Model: AP-P2	Date: 11-Dec-08	No.: RG188001e
---------------------	-----------------	----------------

Subject: Firmware Release Note: Engine		Prepared by: M. Kumagai	
From: 1st Overseas Tech Support Sec., 1st PQM Dept.			
Classification:	<input type="checkbox"/> Troubleshooting	<input type="checkbox"/> Part information	<input type="checkbox"/> Action required
	<input type="checkbox"/> Mechanical	<input type="checkbox"/> Electrical	<input type="checkbox"/> Service manual revision
	<input type="checkbox"/> Paper path	<input type="checkbox"/> Transmit/receive	<input type="checkbox"/> Retrofit information
	<input checked="" type="checkbox"/> Other ()

Model: AP-P2		Date:29-Jun-09	No.: RG188016
Subject: Toner blasting		Prepared by: N.Yoshida	
From: 2nd Tech Support Sec. Service Support Dept.			
Classification:	<input checked="" type="checkbox"/> Troubleshooting	<input type="checkbox"/> Part information	<input type="checkbox"/> Action required
	<input type="checkbox"/> Mechanical	<input type="checkbox"/> Electrical	<input type="checkbox"/> Service manual revision
	<input type="checkbox"/> Paper path	<input type="checkbox"/> Transmit/receive	<input type="checkbox"/> Retrofit information

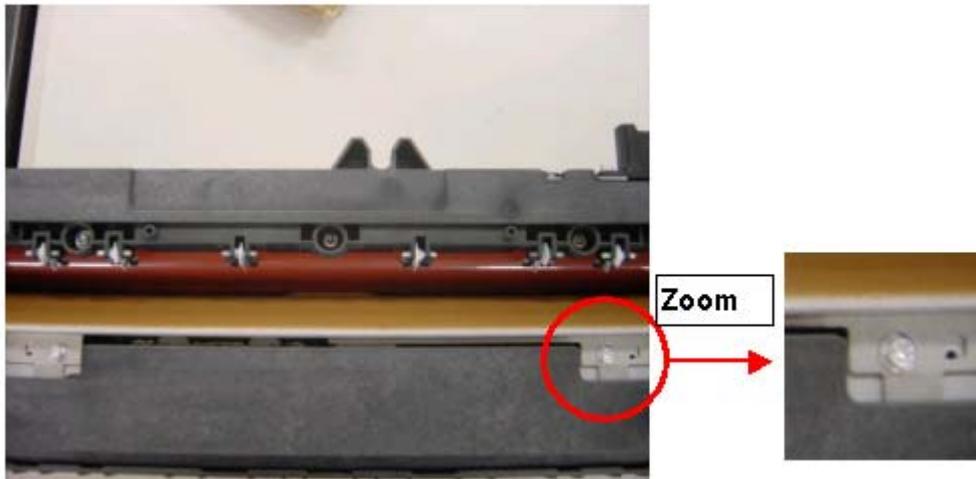
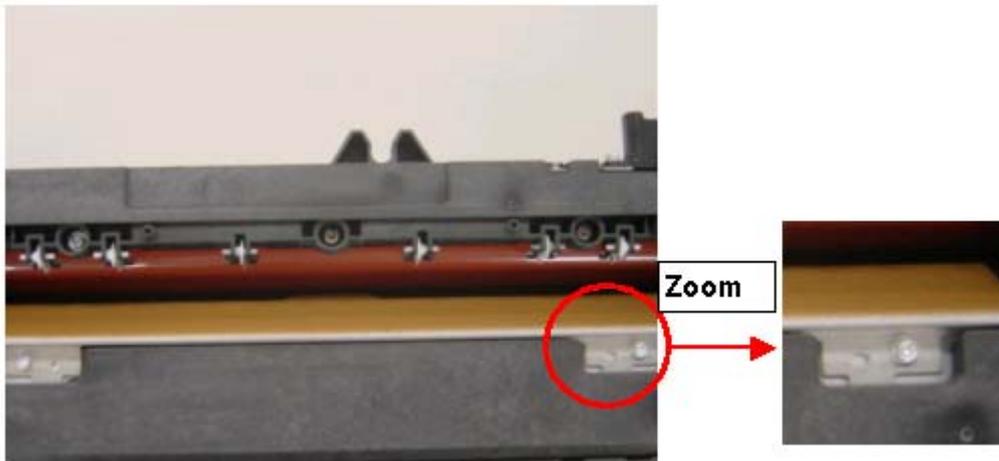
2. Change the position of the fusing guide plate.

- Change the position of the screw shown below, and then move the guide plate toward the pressure roller.

After this screw position is changed, in some cases, mimizu ('earth worms', slight wrinkling) may occur with the first print made of the day.

13. Attach the pressure roller contact motor [I] (screw x 4) in the “NEW” orientation shown below.

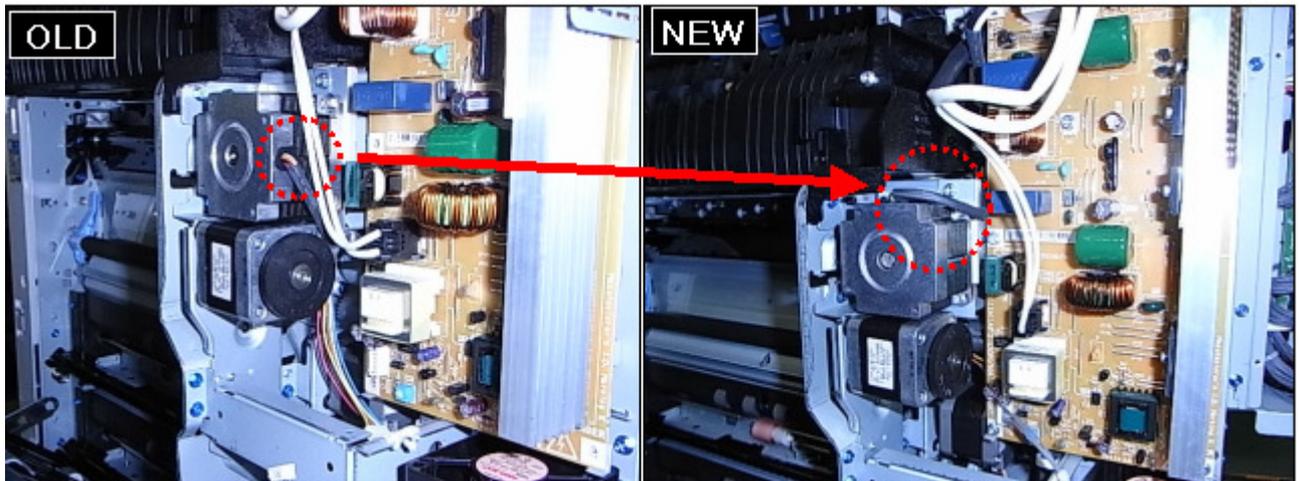
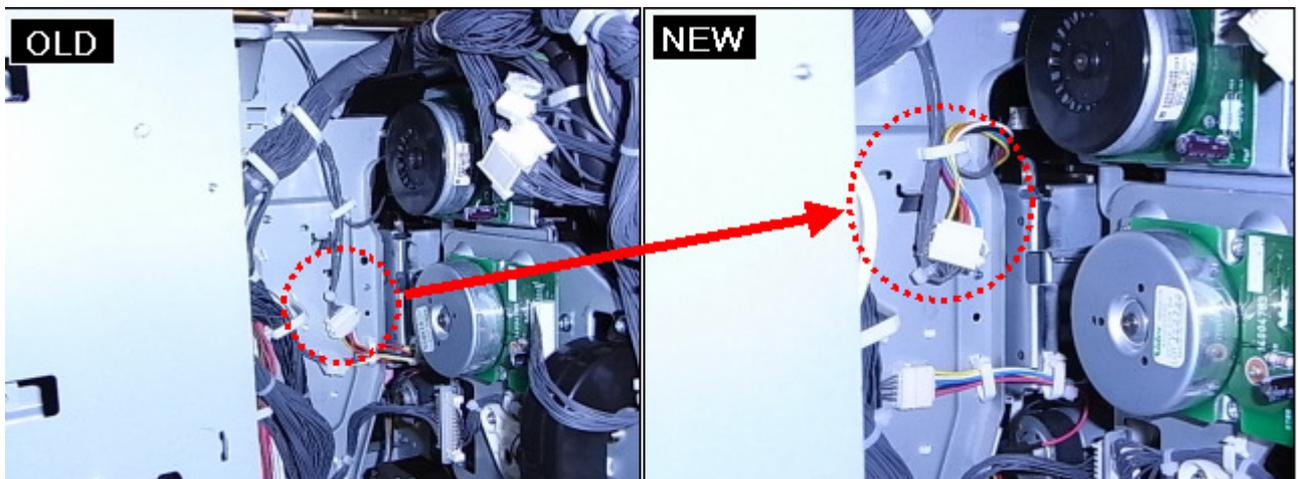
Important: Make sure that the opening in the pressure contact motor for the harness is **facing up** (and not right). This is to prevent the harness from touching the wheel of the duplex bypass motor.

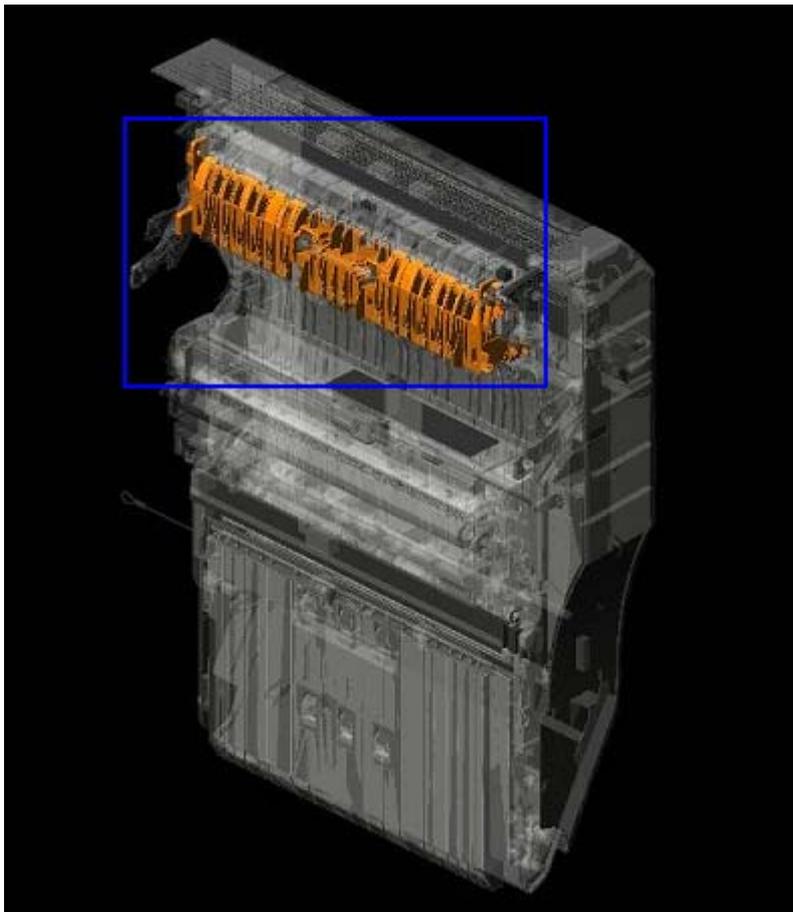
JAM 64 or 67 occurs in the duplex unit.

High temperature and a mechanical load cause the fusing entrance guide plate to bend.

Replace the guide plate with the new part shown below.

Change: A stay was added inside the guide plate.

Fig. 1

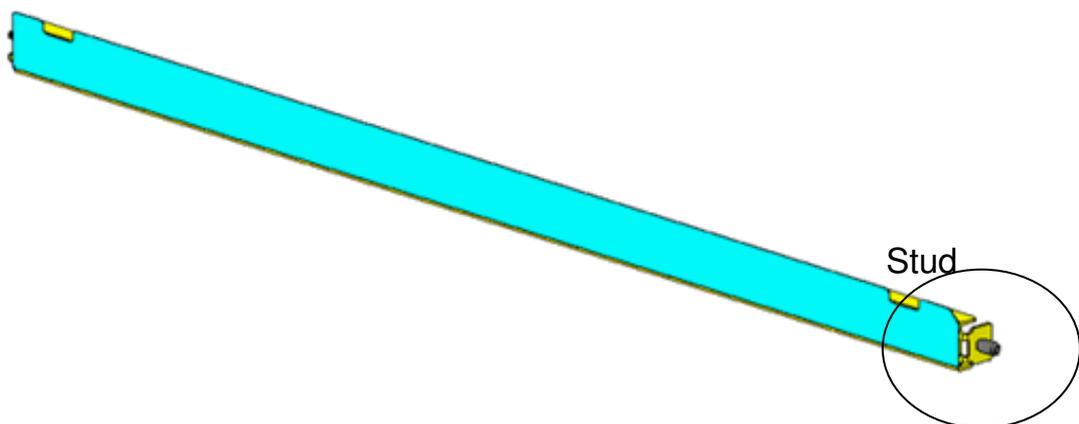
1. The bracket with a screw hole at the front side of the stay was changed to a stud fixture.
2. The torque specification for the screw (still used at the rear side) was changed from $0.7 \pm 0.1 \text{N/m}$ to $0.5 \pm 0.1 \text{N/m}$.
3. This stay is now included in the service parts assembly shown in the table above (see Fig. 2)

Reason: To prevent paper jams by minimizing the range of motion (twisting) of the stay.

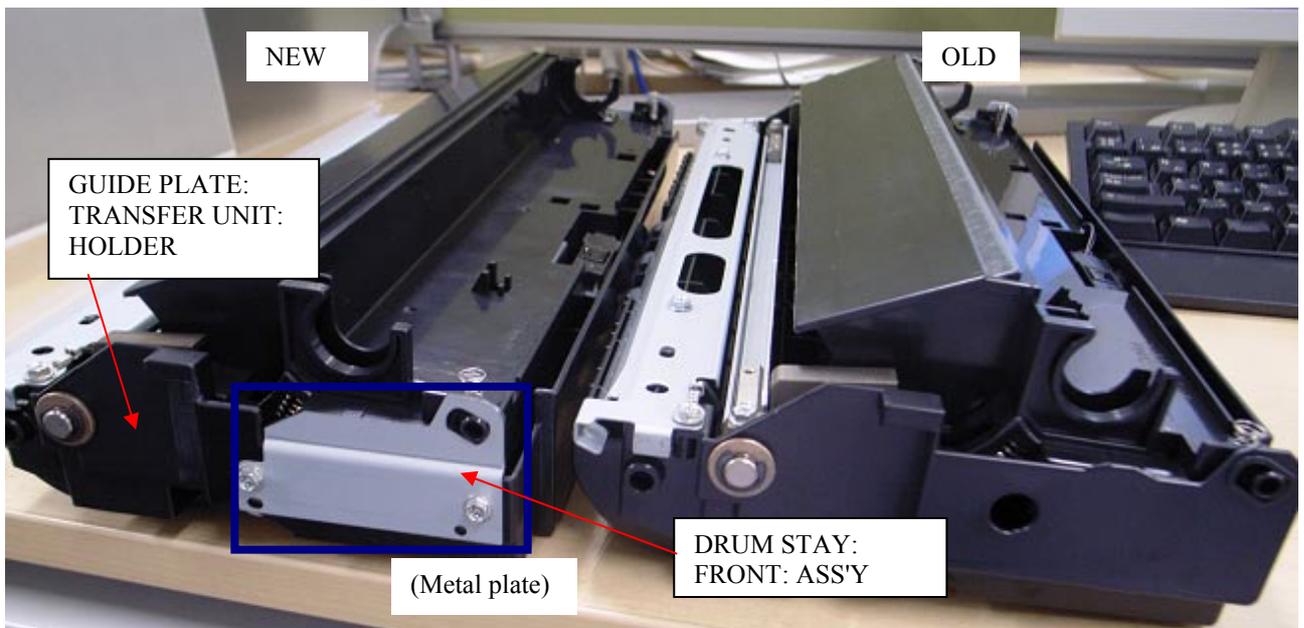
Change: The material of the parts was changed from a resin to a metal.

Reason: To further increase the load-bearing strength of the parts.

Important: Interchangeability is **X/O as a set** (all six parts together).
